Memorandum

Subject: Pre-application: Z2025000111
Applicant Name: 8445 SW 94th Street Mixed-Use Building

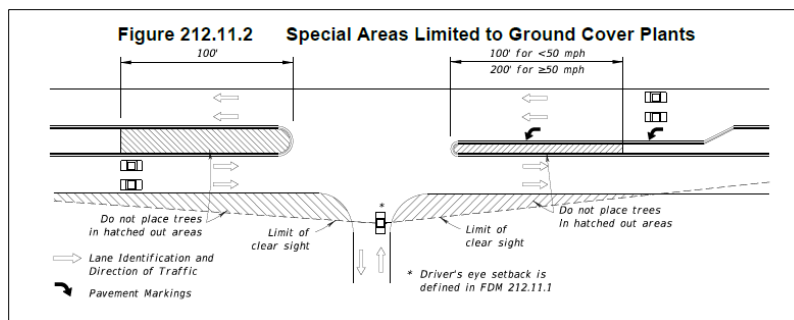
1. Exit driveways must comply with clear sight visibility requirements for both pedestrians and vehicular traffic. Provide clear sight visibility triangles on the site and landscape plans to demonstrate compliance with these requirements. Please ensure to clearly illustrate both (pedestrian and vehicular) sight triangles following the MDC Traffic Operations Manual and FDOT Standards. Note that according to the latest FDOT FDM manual

Section 212.11.6, trees may not be placed within the hatched-out areas of the sight triangles, as shown in the figure below.
